From: Fernandez, Frank [Frank.Fernandez@encana.com]
Sent: Sunday, August 15, 2010 1:35 PM
To: Fernandez, Frank; Andrews, David
Cc: Asuchak, Edward A.; Candelaria, Larry R.
Subject: RE: WF04B-22 surface depth request

Regarding Patterson rig 303 drilling ops on Encana's K22 pad.

Regarding WF04B-22 (K22), API# 05-04-18861-00

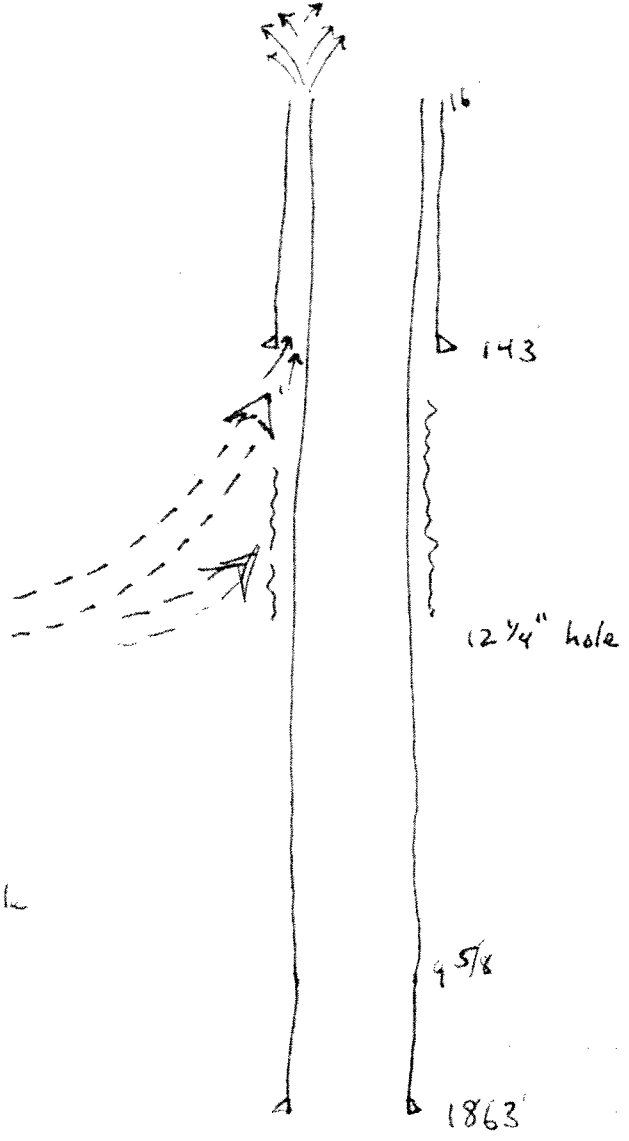
140-22

04B-22

WF140-22

$$\frac{15.75^2 - 4.5^2}{1029.4} (113) = 31.7$$

$$\frac{12.25^2 - 4.5^2}{1029.4} (59) = 7.4$$

$$\frac{12.25 - 4.5^2}{1029.4} (138) = 17.4$$

WF04B-22

$$\frac{15.75^2 - 9.625^2}{1029.4} (113) = 21.6$$

$$\frac{12.25^2 - 9.625^2}{1029.4} (59) = 3.3$$

① → 81.4 bbls plus fracture system

② → 100 bbls

③ → 100% excess

④ → 200 bbls cement ordered

$$\textcircled{5} \rightarrow 200 \text{ bbl cement} \left| \frac{5.6 \text{ cu ft}}{1 \text{ bbl}} \right| \left| \frac{1 \text{ sq}}{1.17 \text{ cu ft}} \right| = 757 \text{ sq cement}$$
